# Southampton to London Pipeline Project

Response to Action Points from the Issue Specific Hearing  
on Environmental Matters on 3 December 2019 (ISH2)

Application Document: 8.20

December 2019

Action No.	Action:	Applicant response to Action:
		<p><b>Figure 1.8 – Plan showing Narrow Working through Fordbridge Park</b></p>

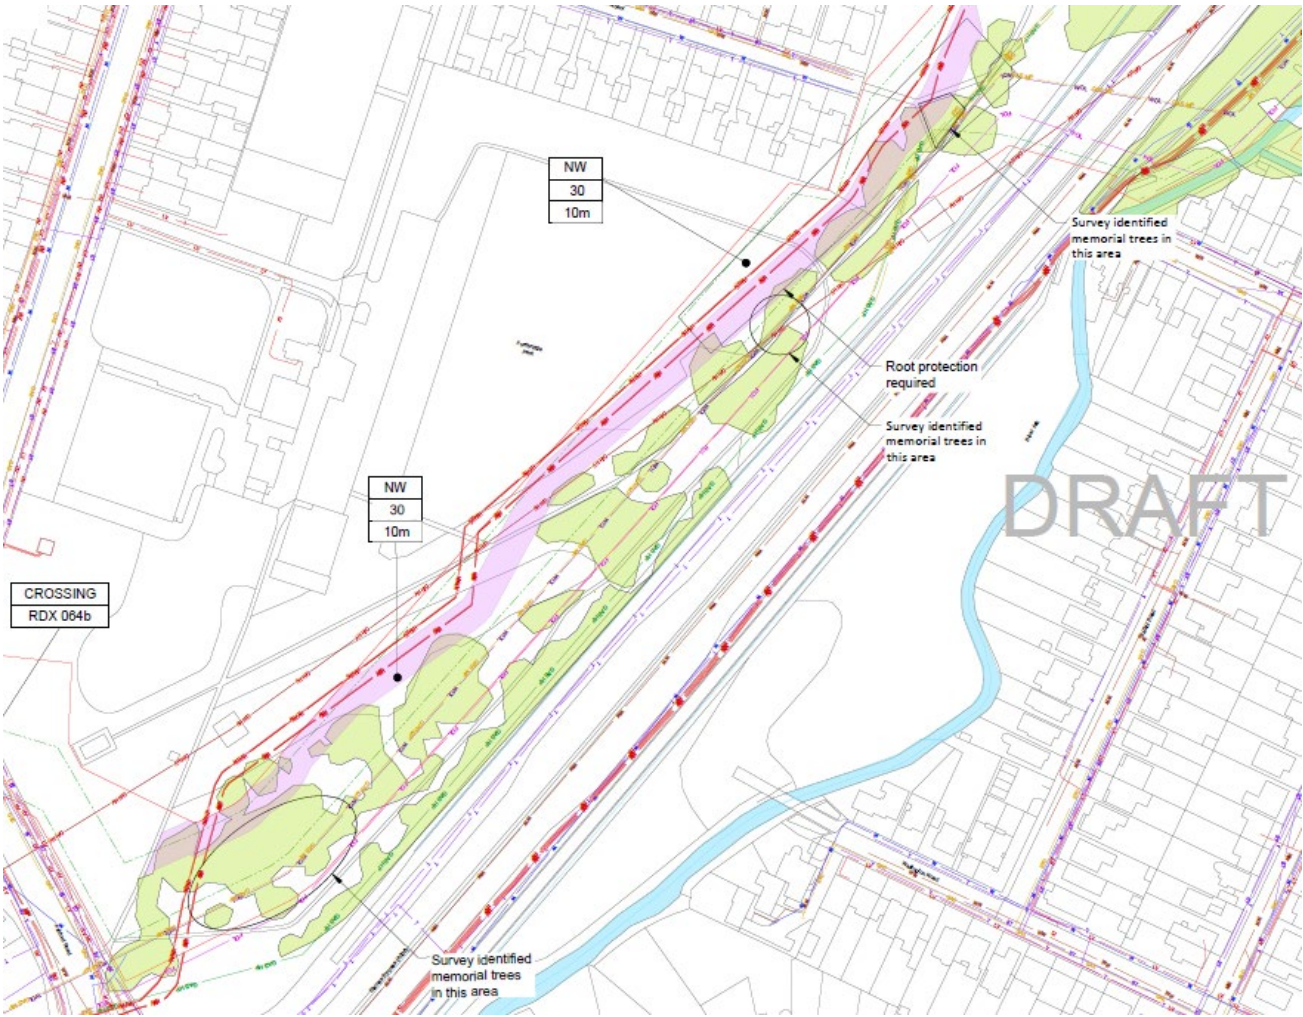
Action No.	Action:	Applicant response to Action:
		At Turf Hill, the F1a option follows an existing pathway through coniferous plantation woodland which is sub-optimal habitat for sand lizard. This would avoid the direct impact and complex mitigation required for sand lizard required for the F1b and F1c options. Further, the habitats along the central F1c route are used by the Special Protection Area (SPA) breeding birds, notably Dartford warbler, which breeds in gorse and heather, whereas the habitats along the F1a route are sub-optimal. Avoidance of the F1c route therefore also helps to reduce effects on habitats used by SPA breeding birds.
35	Provide a summary on route selection for Fordbridge Park and in particular why the route would go through the section of the park where the majority of trees are located rather than the adjacent area of open grass	<p>When selecting the route, the Applicant looked to avoid the area of open grass to the south and the existing utility corridor towards the north edge of the park. This maximises the amount of open space available in the park. In recognition of the trees in this area (including the memorial trees) the Applicant has introduced Narrow Working techniques which would weave around the trees and overhead powerline towers in the park.</p> <p>The narrow working area – NW30 in Fordbridge Park is 10m width. The Applicant has provided an alignment sketch below (Figure 1.7) which shows an indicative pipe alignment and narrow working width towards the southern extent of the LOD and skirting the edge of the majority of the trees. General narrow working principles are noted below:</p> <p>Narrow Working @ 10m:</p> <ul style="list-style-type: none"> <li>• Limited turf removal and topsoil strip, to the minimum to allow the pipe to be installed;</li> <li>• Extensive use of ground protection track/matting or similar, to minimise turf damage;</li> <li>• No backfill material stored in the work area;</li> <li>• Utilisation of appropriately sized machinery for the given working width – non-metal tracked machines and smaller excavators;</li> <li>• Site fencing to utilise non-intrusive water-filled or similar base fixings so as not to impact on the surface below;</li> </ul>

Action No.	Action:	Applicant response to Action:
		<ul style="list-style-type: none"><li>• In certain locations hand digging and other techniques will be required to reduce impacts in root protection areas; and</li><li>• Trenching boxes and temporary sidewall support to be used rather than battering back (sloping) of trenches, to reduce width of trench to a minimum.</li></ul>

**Figure 4: Indicative Section showing temporary timber and boarding to bridge over cut hedge stems**

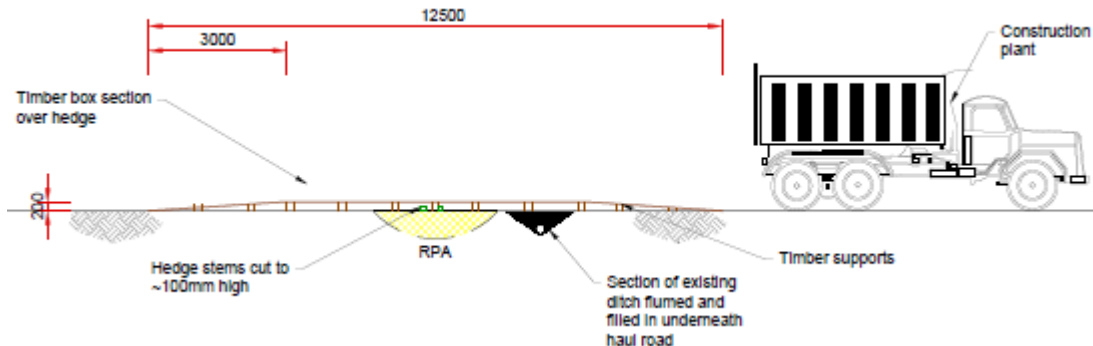
1. Across a narrowed width of approximately 5m, the existing hedge will be coppiced down leaving stumps approximately 150mm above existing ground level.
2. A layer of wood chip 100-150mm deep will be applied around the stumps to provide a level of protection and to help retain moisture.
3. A horizontal framework of timber will be installed in between the hedge stumps as shown Figure 3 below.

4. Boarding or bog mats will then be installed above the timber. The boarding will be supported by the timbers thereby ensuring that the hedge stumps are not directly trafficked on. Gaps will be left between each board to ensure the ingress of rainwater. This arrangement will be used to enable construction vehicles to cross from one side of the hedge to the other.
5. The Ecological Clerk of Works will ensure that the condition of the coppiced stumps is monitored and appropriate care given to ensure that they remain watered and in suitable condition for the duration that the haul road is in place.

**Figure 6: Indicative Section showing installation SLP under hedge**

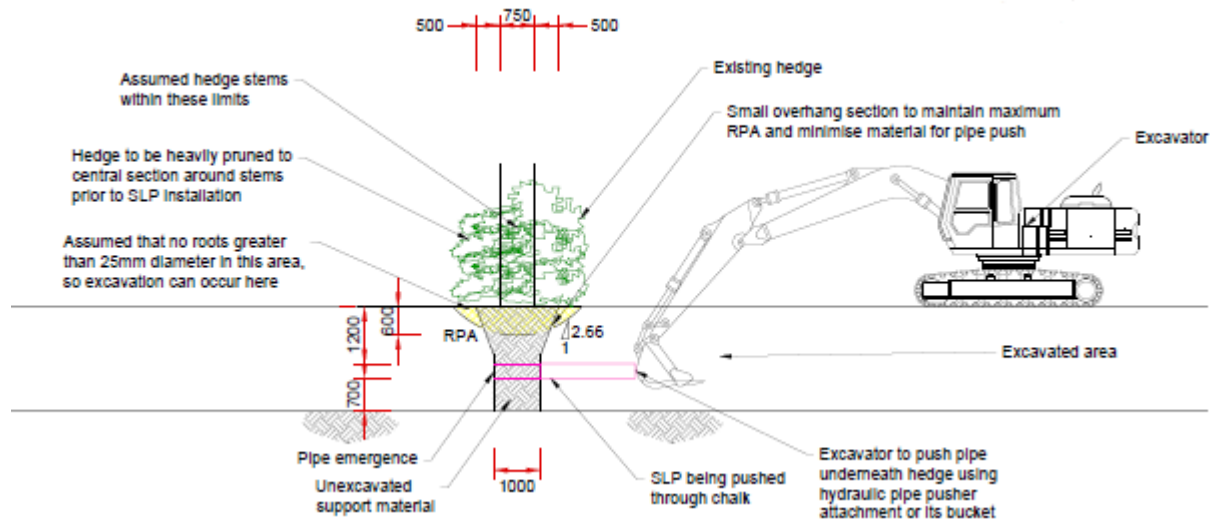
7. The excavator bucket will then be used to excavate under the hedge roots as shown in Figure below. This excavation will be done from either side of the hedge to leave circa 1m width of unexcavated material directly under the hedge.

**Figure 7: Indicative Section showing temporary timber and boarding to bridge over laid hedge stems**

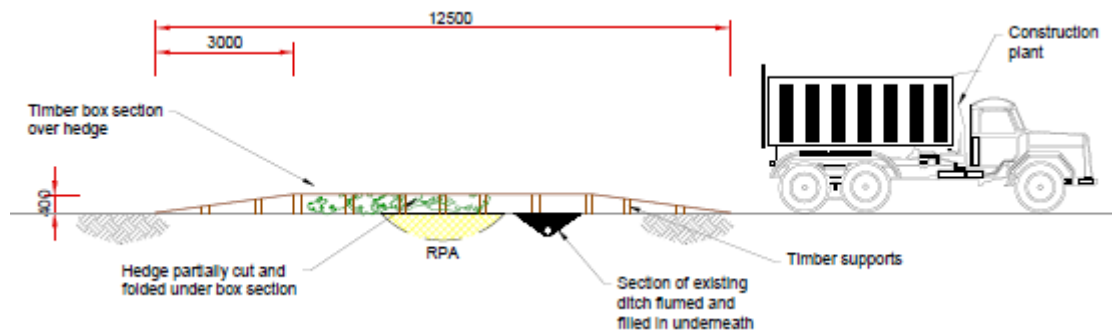
1. Across a narrowed width of approximately 5m, the existing hedge will be heavily pruned. The stems will then be professionally laid.
2. A layer of wood chip 100-150mm deep will be applied around the stems to provide a level of protection and to help retain moisture. A horizontal framework of timber will be installed in between the laid over hedge as shown in Figure 6.
3. Steps 3 – 9 from Option 1 above will be followed.
4. The bog mats or timber bridging will be removed and vertical posts installed in between the laid stems.
5. The laid stems will be lifted and woven around the vertical posts to provide a traditional laid hedge.
